Braidwood Station, Units 1 and 2
Facility Operating License Nos. NPF-72 and NPF-77
NRC Docket Nos. STN 50-456 and STN 50-457

Byron Station, Units 1 and 2
Facility Operating License Nos. NPF-37 and NPF-66
NRC Docket Nos. STN 50-454 and STN 50-455

Subject: Additional Information Supporting Request for License Amendment
Regarding Measurement Uncertainty Recapture Power Uprate

**RESPONSE TO REQUEST FOR
ADDITIONAL INFORMATION
NRC Letter dated December 6, 2012
[ML12271A308]**

Figure 3-1a: Previous Analysis – EDG Temperature Profile – To Fire Damper Closure

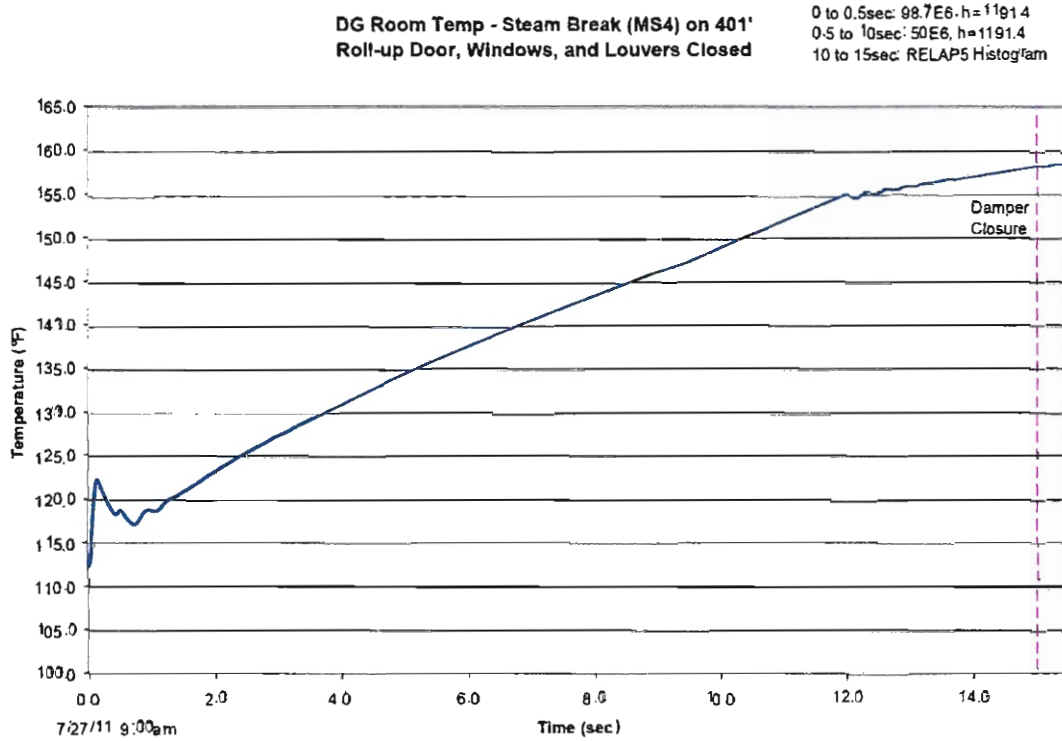
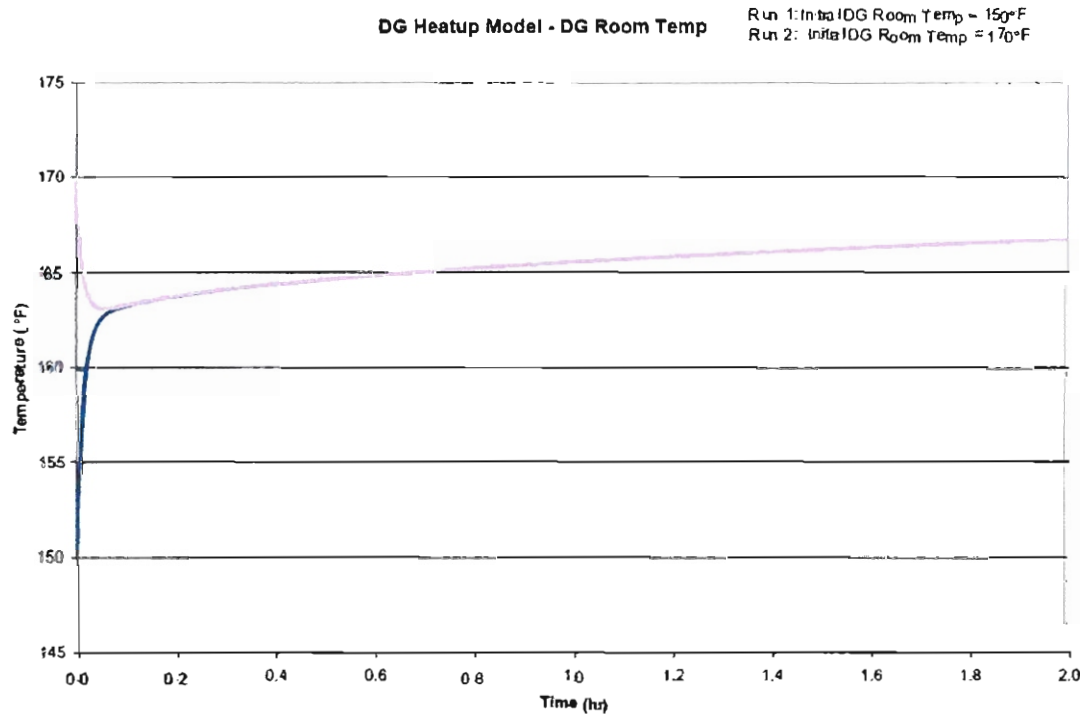
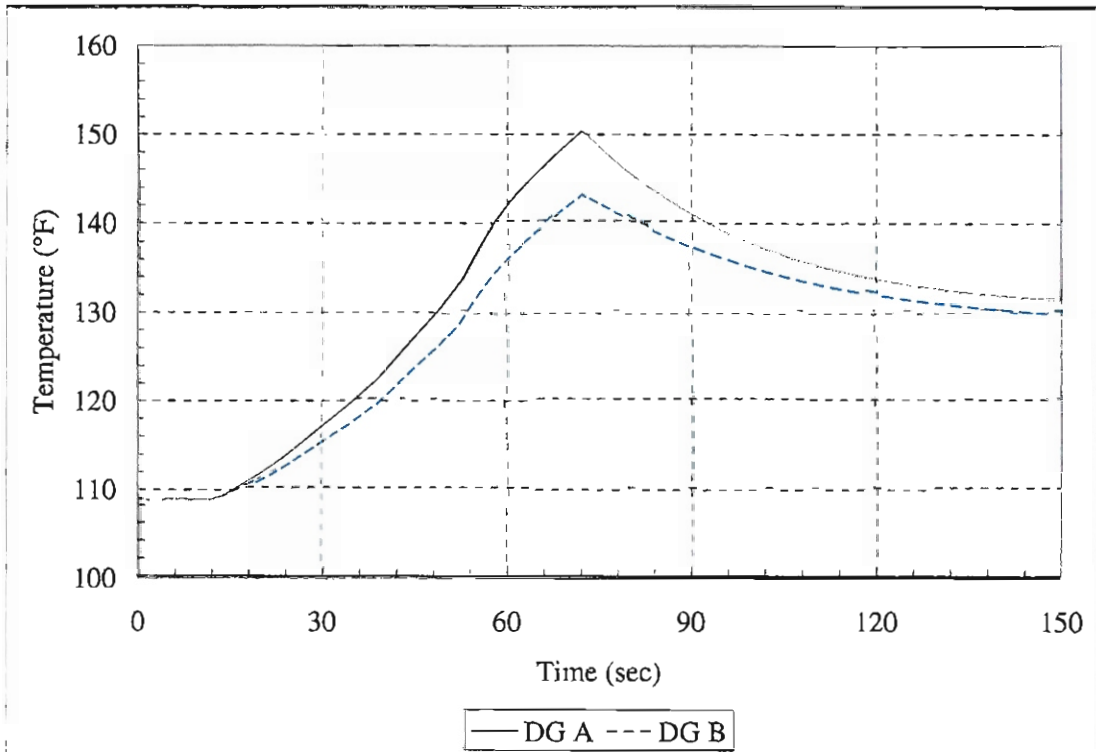
- h. Provide plots of important parameters and explicitly identify those that changed as a result of the resolution of the nonconformance.***

In the previous analysis, the initial temperature increases rapidly in the rooms until the fire dampers are assumed to close, once the fire damper is assumed closed the rooms continue to heat up due to the loss of ventilation but at a slower rate until the ventilation is assumed to be manually restored after 2 hours. The temperature profile for the EDG Rooms (Figure 3-1a) rapidly increases to approximately 158°F until the fire damper closes then the room trends to 167°F until ventilation is restored (Figure 3-1b). The temperature profile for the ESF Switchgear rooms (Figure 3-3a) rapidly increases to approximately 165°F until the fire damper closes then the room trends to 160°F until ventilation is restored (Figure 3-3b). The temperature profile for the MEER rapidly increases to approximately 175°F for the Division 11 room and to approximately 140°F for the Division 12 room (Figure 3-5a) until the fire damper closes then the Division 11 room trends to 128°F (Figure 3-5b) and the Division 12 room trends to 132°F (Figure 3-5c) until ventilation is restored.

The new analysis credits the backdraft/reverse flow dampers and other modifications installed to implement the revised TB HELB mitigation strategy. These changes minimize the introduction of hot air and steam into the rooms and permit the rapid automatic restoration of ventilation to restore room temperatures. The resulting worst case temperature profiles for the EDG Rooms, ESF Switchgear Rooms, and MEER are provided in Figures 3-2, 3-4 and 3-6, respectively. These temperature profiles indicate that the peak temperatures are consistent with the requirements of Technical Requirements Manual (TRM) 3.7.d (as shown in Table 3-1), in that the temperatures are rapidly restored to below the Operating Limit well within the allowed 8 hours specified in the TRM, and remain well below the TRM Operating Limit +30°F.
